From: Eudy, Michael
Sent: Friday, March 07, 2014 1:01 PM
To: ArevaEPRDCPEm Resource
Cc: McLellan, Judith; Wunder, George
Subject: FW: RAI 579 Q19-366 (discussion version)
Attachments: Response RAI 579 Q19-366 - Revision.pdf; RAI 579 S1 FSAR Markups.pdf

Request for Additional Information No.579, Supplement 1

U.S. EPR Standard Design Certification

Question 19-366:

Figure 7.3-2—SIS Actuation

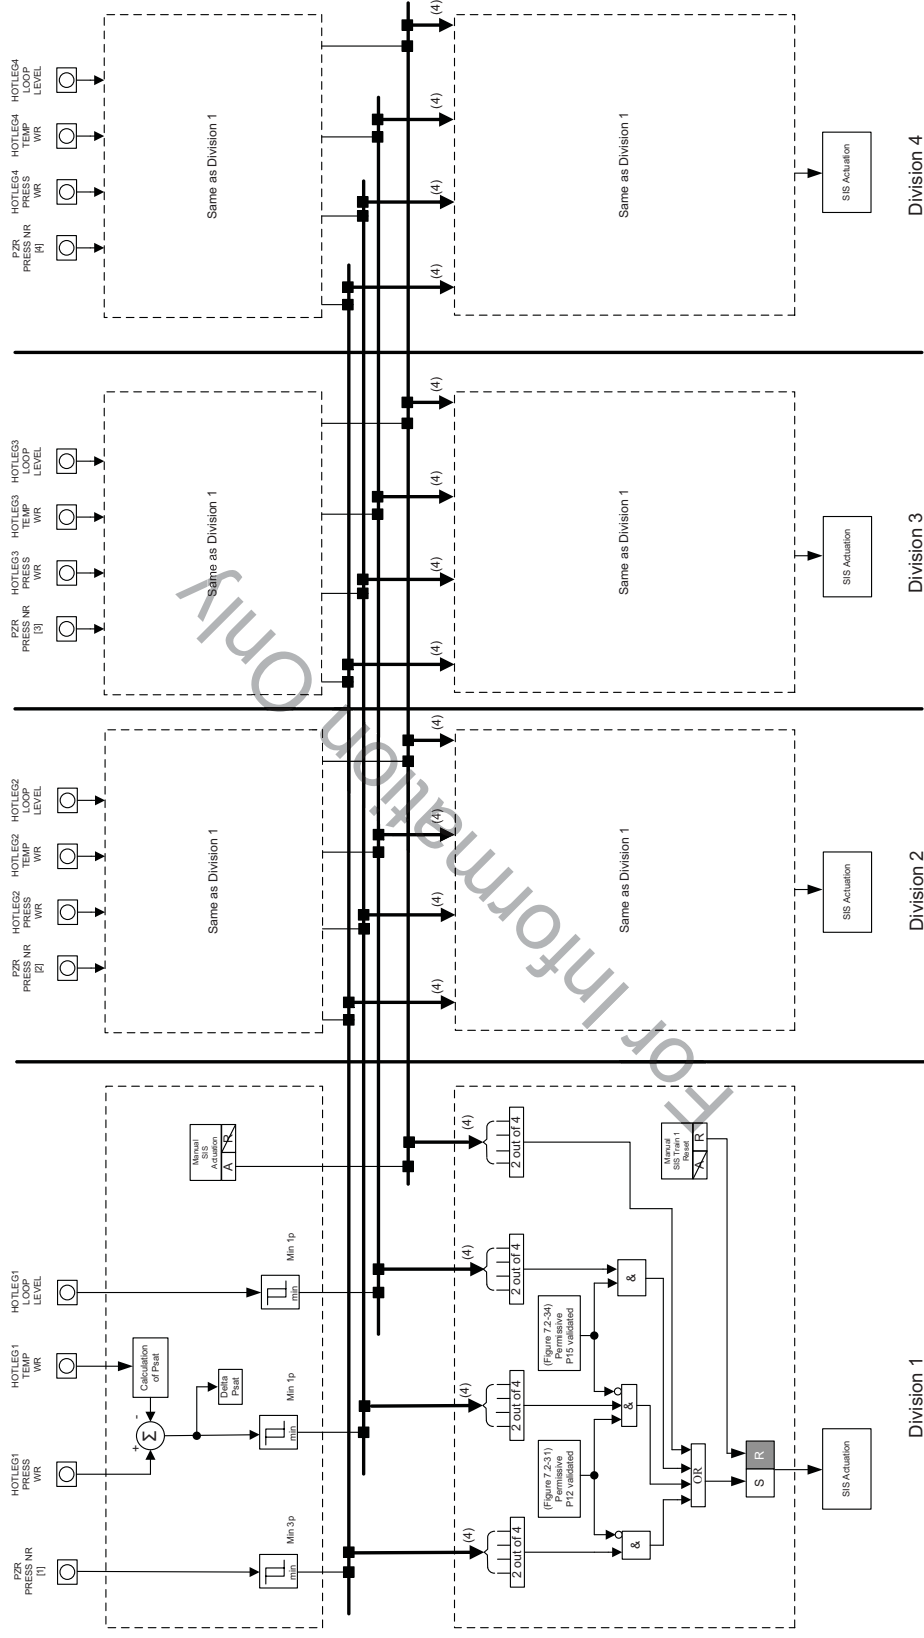
The staff then reviewed insight 20 on Table 19.1-108 - US EPR PRA Based Insights. Insight 20 reads, "In shutdown operation, automatic MHSI actuation on a low RCS (hot leg) loop level....". The staff found no discussion in Chapter 19 in the FSAR on the use of the Loop Level Bypass switch that is shown on FSAR Figure 7.3-2 - SIS actuation. The staff also found no discussion in Section 5.4.7.2.1 on the use of the bypass switch. Based on discussions with AREVA at the US EPR audit in February of 2013, use of this bypass switch that would prevent automated safety injection was not modeled in the PRA. Based on conversations with AREVA at the US EPR audit, this bypass switch may be used to prevent automatic actuation of Safety Injection when personnel are performing hot leg and cold leg work (such as installing nozzle dams), the highest risk period during an outage. It was also unclear if this bypass switch would be used during reactor vessel head removal operations. Based on discussions with AREVA staff at the audit, it seems that no criteria was developed documenting when the loop level bypass would be used.

- (1) The staff is requesting that FSAR Chapters 19.1.6 and Chapter 5.4.7.2.1 be revised to account for use of this RCS loop level bypass switch that would prevent automated safety injection during reduced inventory operation when used.

- U.S. EPR Tier 2 Figure 7.3-2 is revised to remove the bypass switch.
- U.S. EPR FSAR Tier 2 Section 7.3.2.1 is revised to remove discussion of the bypass switch.
- Technical Specification 3.3-2 and bases is modified to remove the bypass switch

(RCP) shut down. It is bypassed above the P15 thresholds. ~~A manual bypass of SIS actuation on low hot leg loop level is provided for protection of personnel working in the RCS components during outages.~~
